CITY OF KELOWNA

MEMORANDUM

APPLICATION NO.: OCP04-0018 & Z04-0075

PURPOSE: To amend the Official Community Plan Future Land Use Map to reflect

A.3: Airborne Particle and Visual Screen

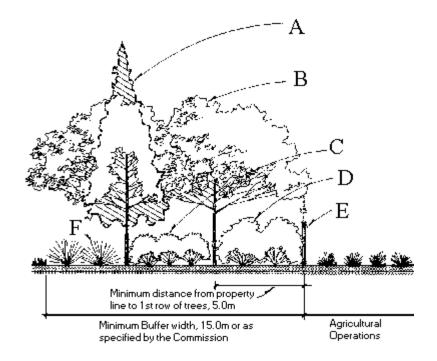
- It should be registered on title that this application is directly across from agricultural land which will be subject to noise, odour, dust, traffic and agricultural practices.
- The buffering standards that the committee recommends should be above and beyond the regular standards set by the City of Kelowna. The AAC strongly recommends that the A3 annual buffering (see attached specifications) be implemented.

- A. Yearly Screen Minimum double row deciduous/coniferous trees. (continuous as shown) See Schedules B.2, C.1 & C.3
- B. Summer Screen Minimum double row deciduous trees. (continuous) See Schedules B.1, C.1. Underplant and Fence as shown.
- C. Minimum triple row trespass inhibiting shrubs. (continuous) See Schedules B.5 & C.5
- D. Minimum double row screening shrubs. (continuous) See Schedules B.6, C.6a & C.6b
- E. Fence as per Schedule D. of Fencing Specifications
